## HISTORIC AND DESIGN REVIEW COMMISSION

August 05, 2015

**HDRC CASE NO:** 2015-298  
**ADDRESS:** 1029 DAWSON ST  
**LEGAL DESCRIPTION:** NCB 2872 BLK N LOT 7  
**ZONING:** R6 H  
**CITY COUNCIL DIST.:** 2  
**DISTRICT:** Dignowity Hill Historic District  
**APPLICANT:** Guadalupe de la Cruz  
**OWNER:** Guadalupe de la Cruz  
**TYPE OF WORK:** Exterior modifications  
**REQUEST:**

# PLOT PLAN

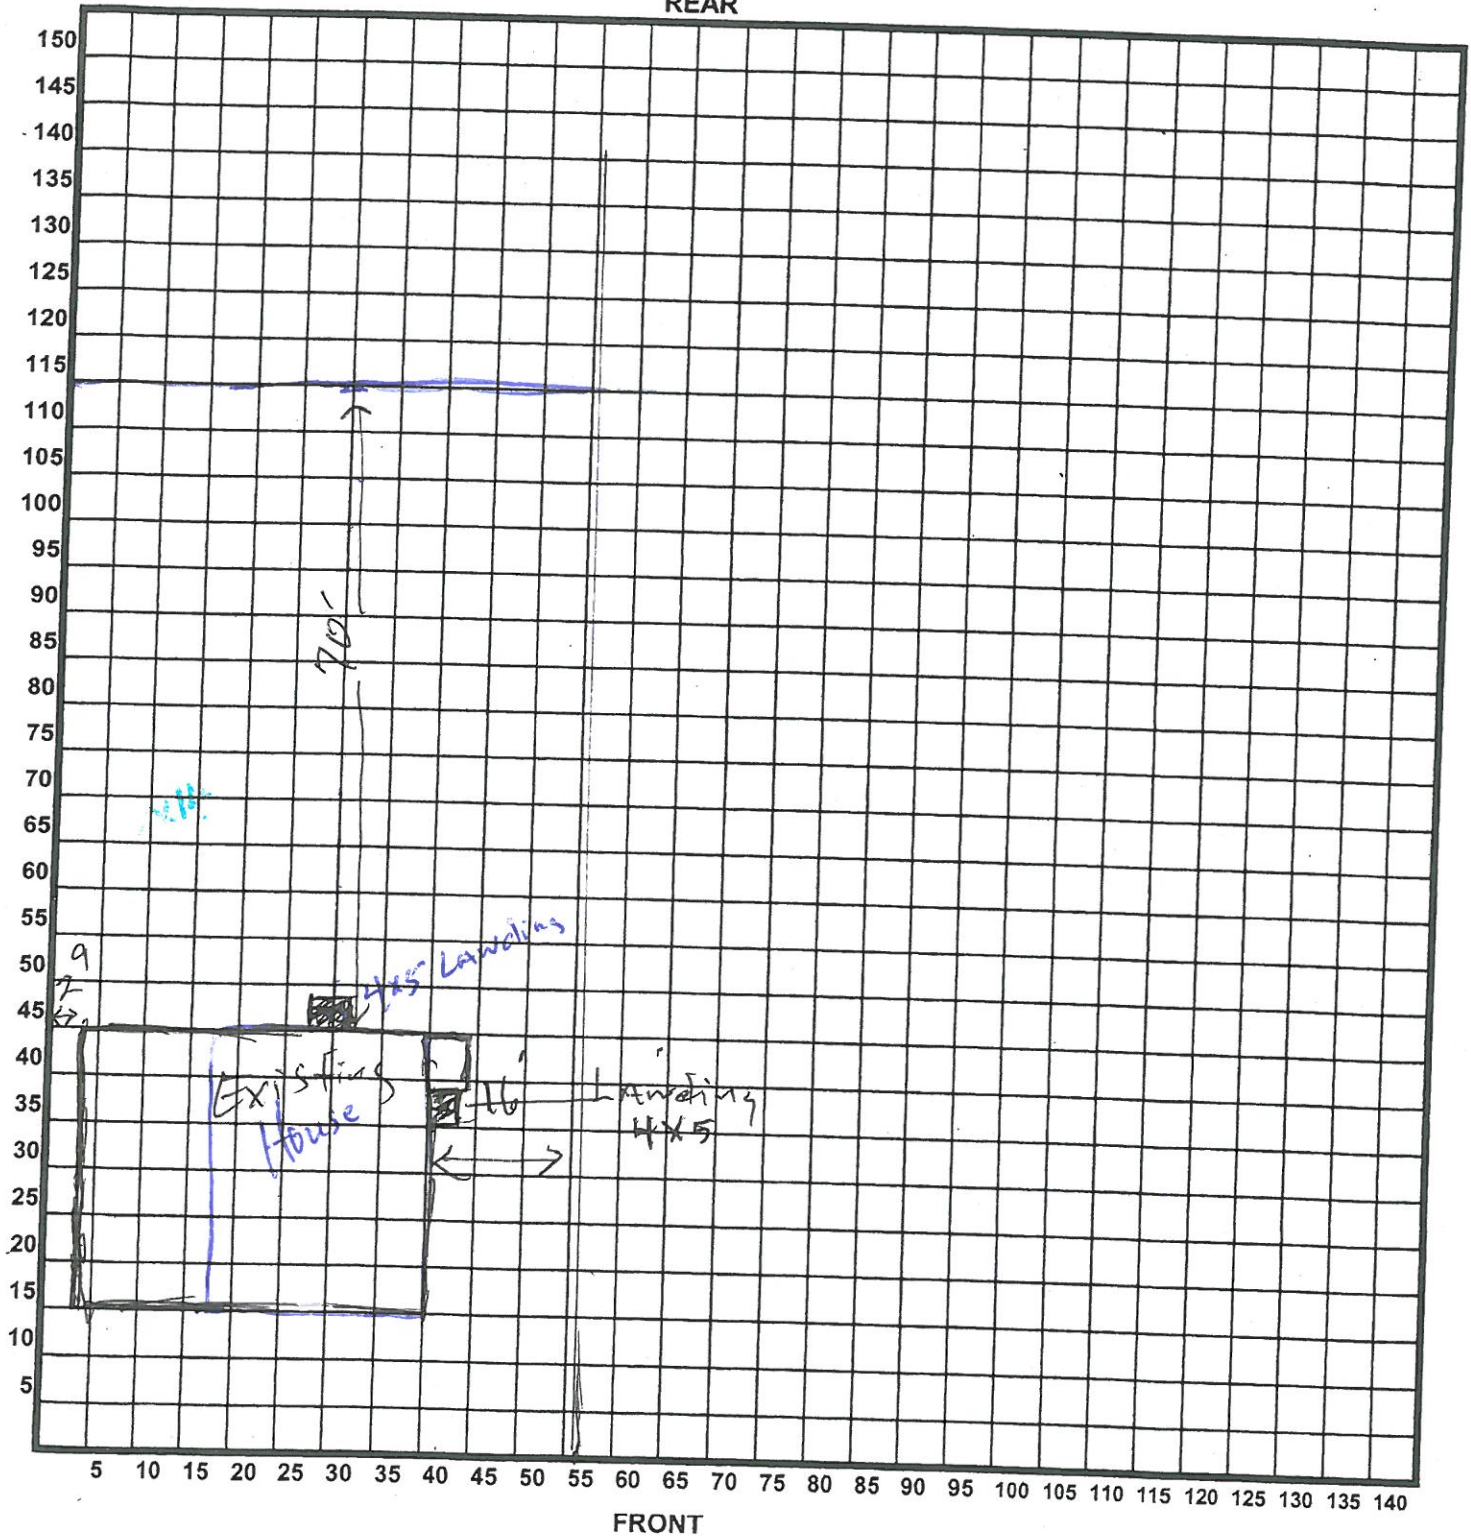
- b. At the rear (north) and side (east) doors, the applicant has proposed to construct 4x5 foot wood landings. While the materials of the proposed landings may be appropriate, staff requests that the applicant provide more detailed architectural documents prior to receiving a Certificate of Appropriateness for the construction of the wood landings.

Staff does not recommend approval of request items # 2 through #6 based on findings b through d. Staff recommends that the applicant adhere to finding c regarding metal roof installation and finding d regarding the removal of original door and window openings as well as original doors and windows.
